January 2023 | Danfoss Climate Solutions for cooling

Cool

Update

Optyma Light Commercial A14 Codes Wiring Diagram Change

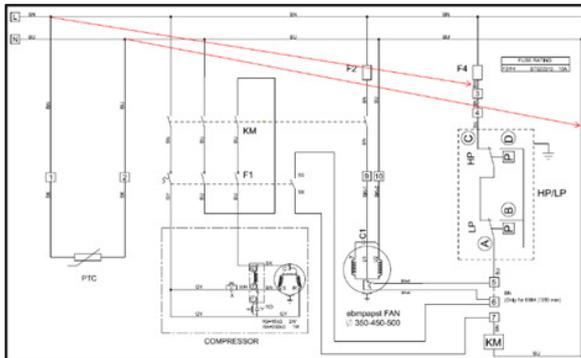
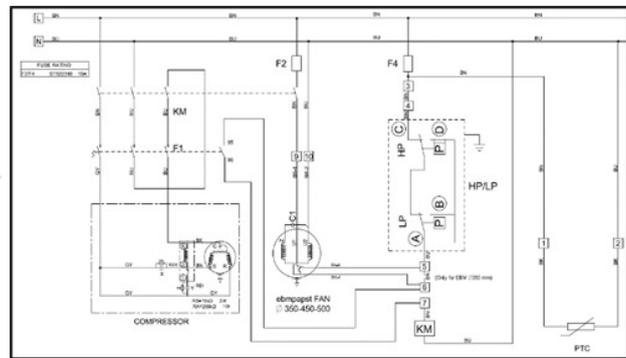
As per wiring drawing the PTC is connected to the power supply however, as a quality improvement measure, we have realized that PTC should be connected to the output (load side) of a control circuit fuse to better protect it against burn in case of a short circuit. The short circuit may happen if the cable insulation is cut and there is contact between a cable and a metal part of a unit.

- Changed internal wiring diagram for quality improvement and safety of PTC against burn in case of short circuit.
- No change in any other features or components.

Changes will be made on new production units and wiring diagram will be updated.

- Wiring diagrams are updated inside the instruction manual and available with unit.
- Instruction manual is also available at the following link: [MANUAL](#)
